Access Compliance Report

Public Rights-of-Way

Intersection ID: 22054	Main Street: MAPLERIDGE_DR	Cross Street: STARVALLEY_DR	Location: NW
ADA ID: 67FD770E9D7F	Ramp Type: PerpDiag	Initial Pass/Fail: Fail	Overall Compliance: No
		Severity Score: 40

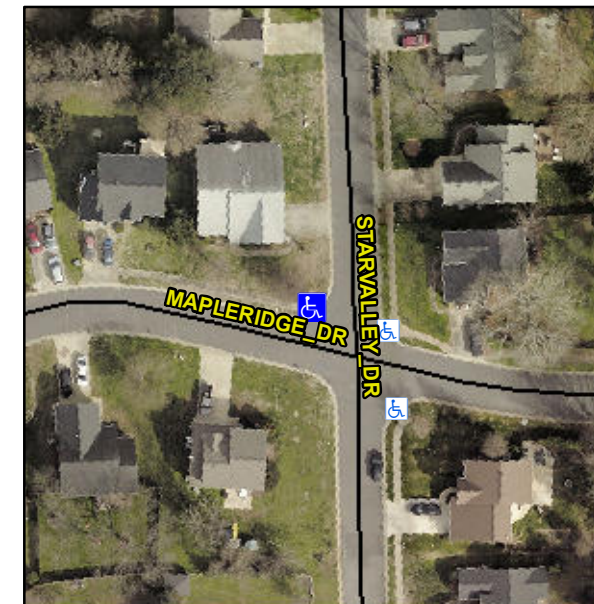
R304.2.2, R304.5.3, R302.7

Compliance	Description	Data	Compliance	Description	Data
N/A	Ramp Length (in)	64.0	No	Ramp Slope (%)	11.4
Yes	Ramp Width (in)	48.0	No	Ramp XSlope (%)	6.3
N/A	Flare Type LT	N/A	N/A	Flare Type RT	N/A
N/A	Flare Slope LT (%)	N/A	N/A	Flare Slope RT (%)	N/A
N/A	Flare Traversable LT?	N/A	N/A	Flare Traversable RT?	N/A
N/A	Landing Length (in)	N/A	N/A	DWS Provided?	N/A
N/A	Landing Width (in)	N/A	N/A	DWS Contrast?	N/A
N/A	Landing Slope (%)	N/A	N/A	DWS Length (in)	N/A
N/A	Landing X Slope (%)	N/A	N/A	DWS Full Width?	N/A
N/A	Landing Curb? (Y/N)	N/A	N/A	DWS Offset (in)	N/A
N/A	Shared Landing?	N/A			
N/A	Gutter Ponding?	N/A	N/A	Gutter Slope (%)	N/A
N/A	Gutter Lip Ht (in)	N/A	N/A	Gutter X Slope (%)	N/A
N/A	Painted X Walk1?	No	N/A	Painted X Walk2?	No
	X Walk 1 Direction	To S		X Walk 2 Direction	To SE
N/A	X Walk 1 Width (in)	N/A	N/A	X Walk 2 Width (in)	N/A
	X Walk 1 Slope (%)	4.8		X Walk 2 Slope (%)	2.5
	X Walk 1 X Slope (%)	1.6		X Walk 2 X Slope (%)	7.0

N/A	Ramp inside XWalk1?	N/A	N/A	Ramp inside XWalk2?	N/A
	Road Slope (%)	4.1	N/A	Clear Space?	N/A
	Road X Slope (%)	7.8	N/A	Clear Space to XWalk (in)	N/A
N/A	Any Obstructions?	N/A	N/A	Storm Grate/Utility Hazard?	N/A
	Obstruction Type			Storm Grate/Utility Type	
		N/A			N/A
		No		Surface Condition? (G/P)	Poor

Remove & Replace Curb Ramp With Two New Directional Ramps or Equivalent.
